Date: TAC Meeting - October 16, 2017

Re: Project "The Residences on Monroe Condominium"

File Number: 17-DP-52

Subject: Site Plan Review for a 40-unit residential development.

GRADING AND DRAINAGE PLAN LOBBY, PARKING & AMENITIES

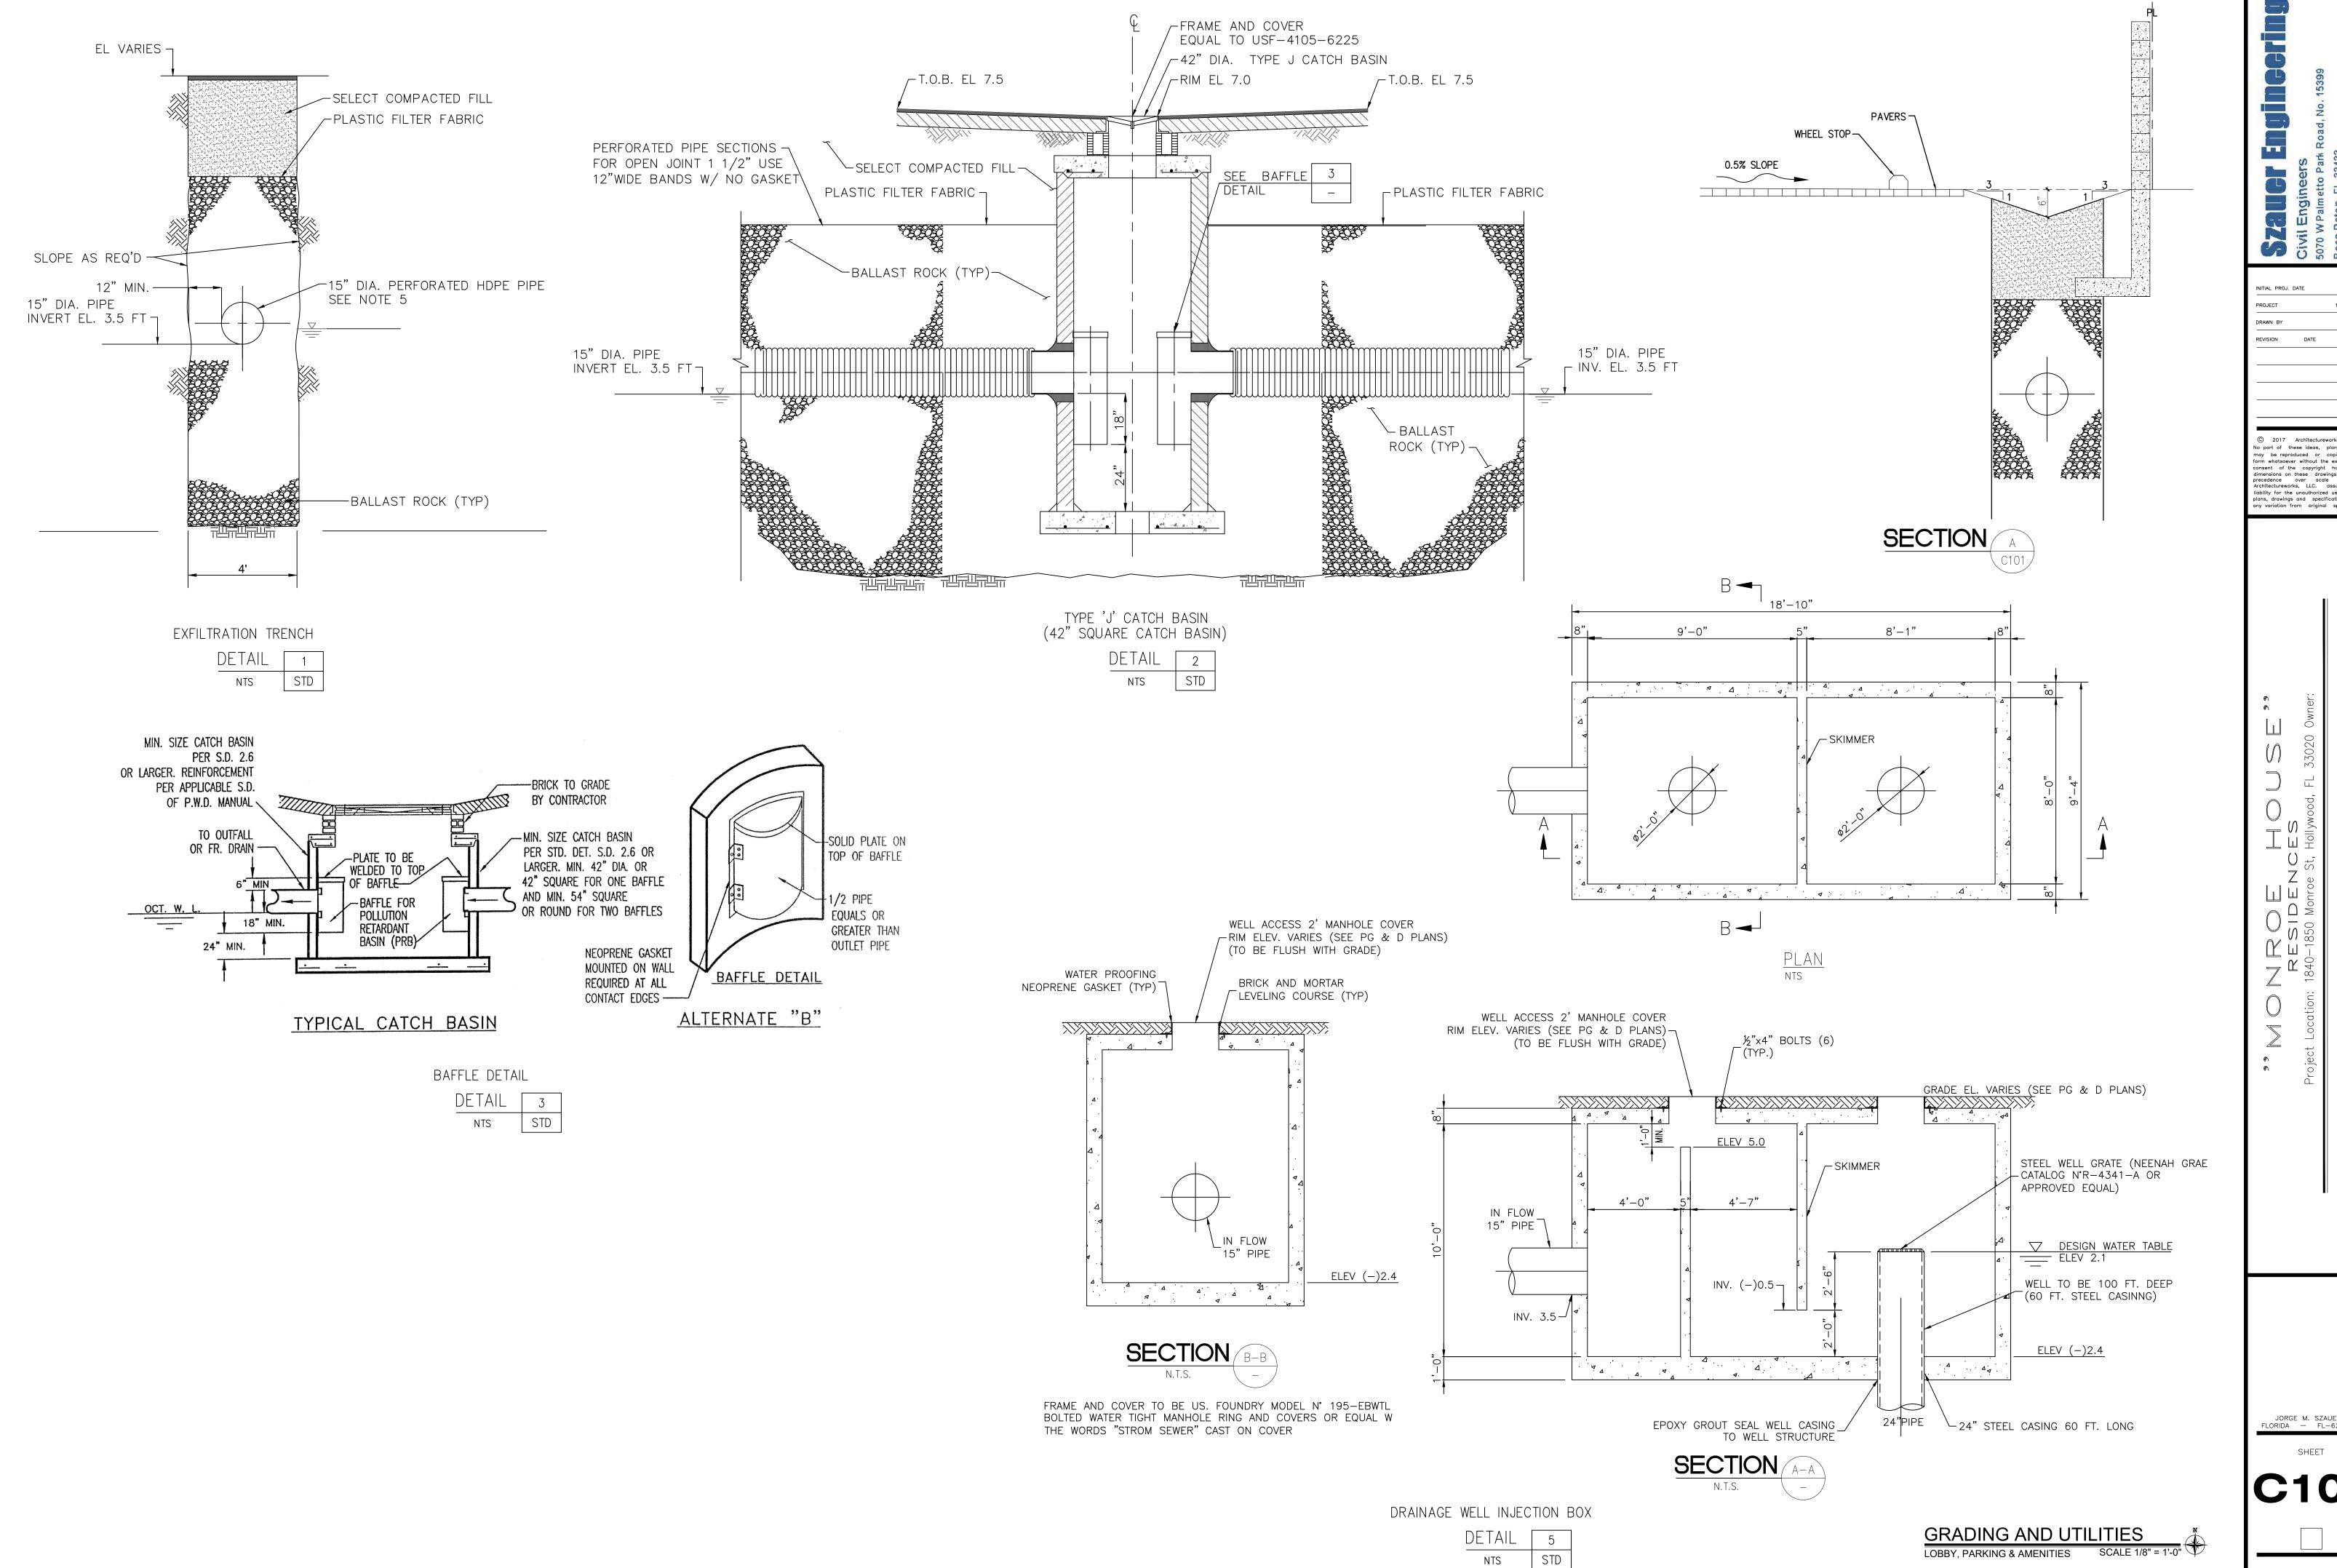
property line per City's standard details. For a copy of the City's standard details, please contact Mike Zaske at (954)921-3930.	
3	Provide water and sewer flow demand calculations on the Water & Sewer flow calculations on Utility Plan sheet C7.	Water and Sewer Flow demand calculations have been included on Sheet C-104 – Utilities Details
Drair	nage Review Comments:	
1	Provide topographic survey of the property. Survey must include FEMA flood zone info, existing adjacent crown of road elevations, property line elevations and onsite elevations. Cover sheet indicated survey was submitted, but none was attached.	Please refer to Survey.
2	Provide two sets of drainage calculations showing pre vs post development stage storage calculations for the 25 year-3 day and 100 year – 3 day storm events. The calculations must clear indicate the peak stages for each of the reference storm events for the pre and post development conditions.	Three sets of drainage calculations are included in this submittal package

3	Provide typical cross-sections across all property lines. Plans must clearly callout a 6" deep perimeter swale, which is to be reflected in the proposed cross-sections.	Typical cross section is included in Sheet C-102
4	Verify that the proposed finished floor elevation is per section 154.50 of the City's Code of Ordinances. Please note that the bottom elevation of all machinery and electrical services serving the building must comply with the minimum finished floor elevation requirement.	Finish Floor Elevation complies with Section 154.50 of the City's Code of Ordinances. Finish Floor Elevation is above the 100-year, 3-day peak stage resulting from site specific flood routing calculations.
5	NPDES – Over 1 acre The construction activity on this site is regulated and required to obtain the NPDES Construction Generic Permit (CGP) from DEP. Failure to obtain permit coverage and/or maintain job site erosion and sedimentation control in accordance with permit conditions and applicable regulations may result in fines up to \$27,500.00 per day. Prior to issuance of building permit a Stormwater Pollution Prevention Plan (SWPPP) shall be required and CGP Notice of Intent (NOI) must be submitted to DEP. SWPPP must be maintained at the job site at all times until the project is terminated and Notice of Termination (NOT) filed with DEP. The SWPPP shall contain detailed descriptions of structures, procedures, contact names and/or control measures designed to reduce sediment and stormwater runoff. Construction sites and operations shall be required to maintain during and after all construction, development, excavation, dewatering, and/or alteration operations, structural and non-structural Best Management Practices (BMP's) with the intent to reduce pollutants and sediment in stormwater runoff. For additional information regarding NPDES regulations please contact: Florida Department of Environmental Protection 2600 Blair Stone Road, MS #2500 Tallahassee, FL 32399-2400 (850) 245-7522 Visit DEP's Web site at: www.dep.state.fl.us/water/stormwater/npdes	Noted
